Port Authority of Allegheny County

North Shore Connector

NSC Train Systems (System Wide)

ADDENDUM NO. 6

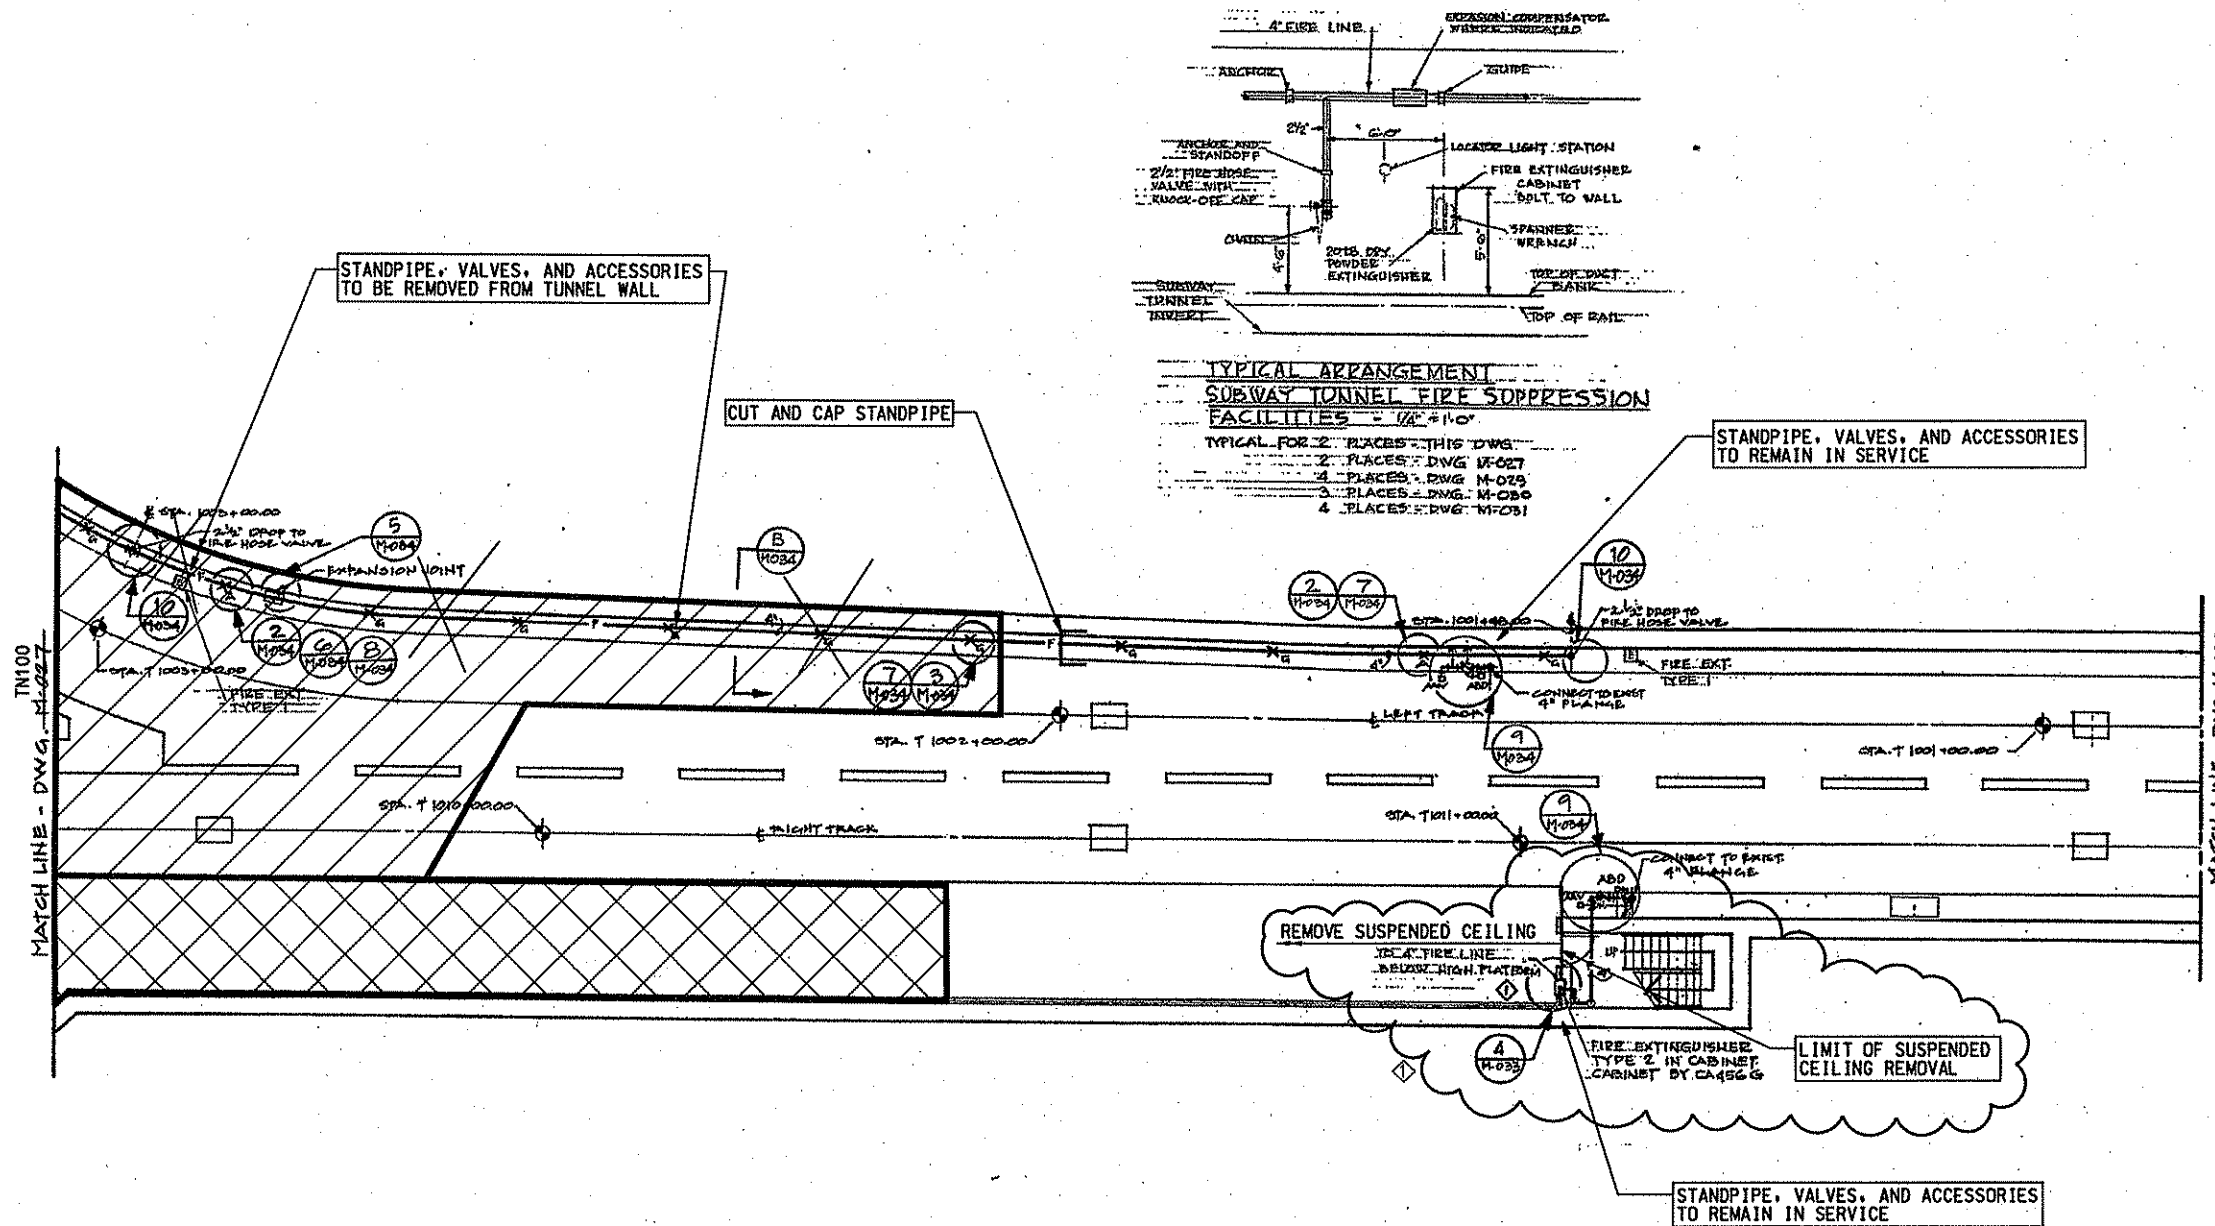
Question 150: Contract Drawing TP217 list conduits AC6, AC7, AC8, and AC9 to be installed under this contract. Please provide physical location of the Fire Alarm panel, EF-1, EF-2, and Air Conditioner that are being powered from Panel PNP in the Tie Breaker room. Please note that the panel schedule on Drawing TP202 does not list these devices being fed from the PNP electrical panel.

Response 150: See Addendum 6.

PORT AUTHORITY OF ALLEGHENY COUNTY
PITTSBURGH, PENNSYLVANIA
NORTH SHORE CONNECTOR
NSC TRAIN SYSTEM (SYSTEM WIDE)
TUNNEL SURVEILLANCE SYSTEM
NORTH SIDE STATION
CONTRACT NO. NSC-009
DWG. NO. CR503
SHT. 600

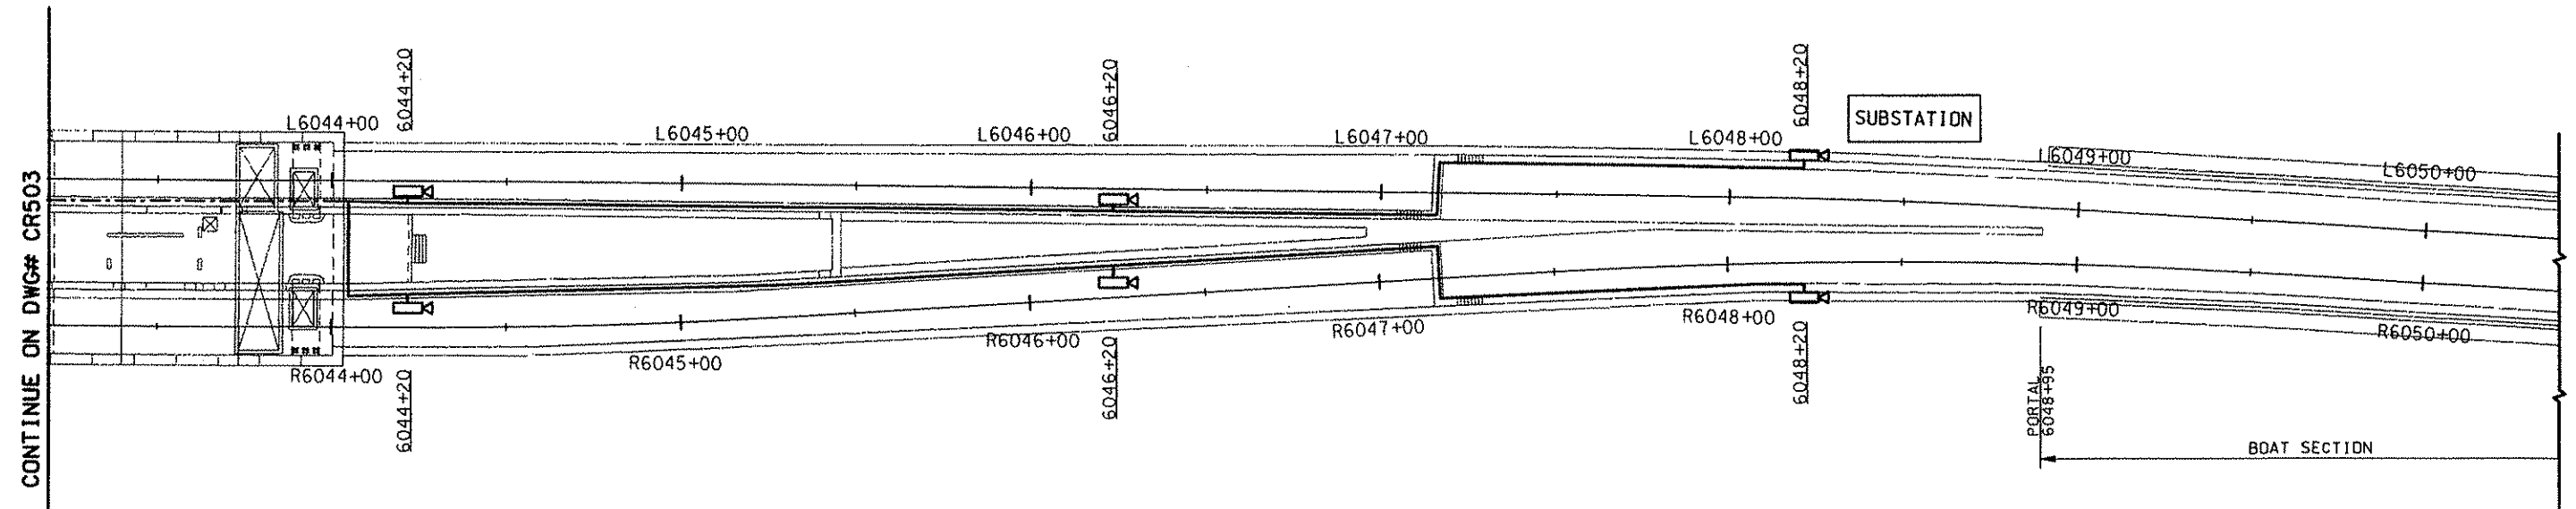
Question 141: We request clarification to Note # 2 as to how it applies to the 6 Fiber Cable and Power Cables shown. Is the NSC-009 contractor to install the cable as shown or only provide the conduit rough-in for future cable installation?

Response 141: See revised drawings CR500 thru CR504 in Addendum 6.

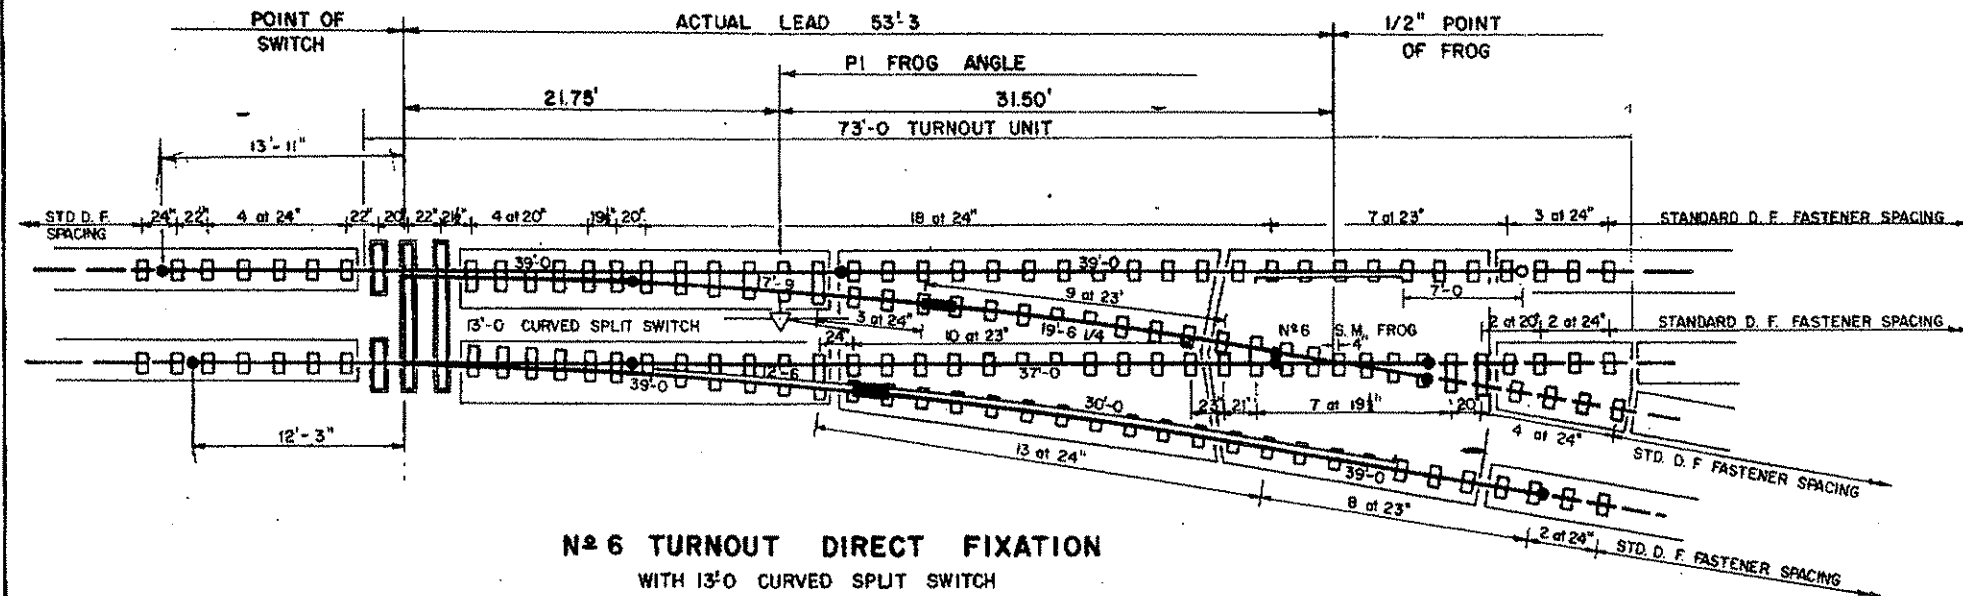
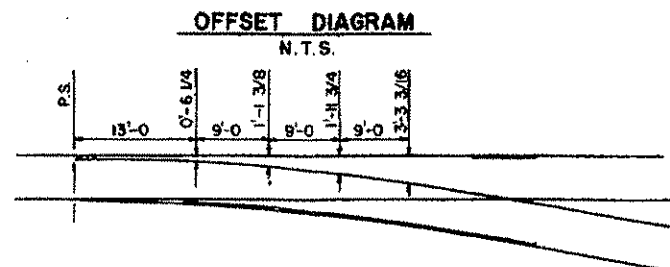
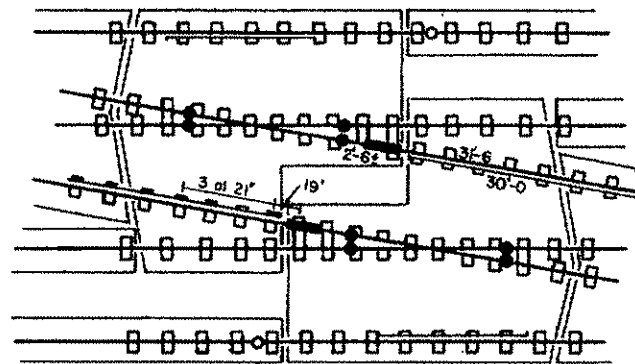
Question 154: Please provide details of the existing #6 crossover at Wood Street Station.

Response 154: See existing #6 crossover plans added to Volume 3 (ALSO Plans).
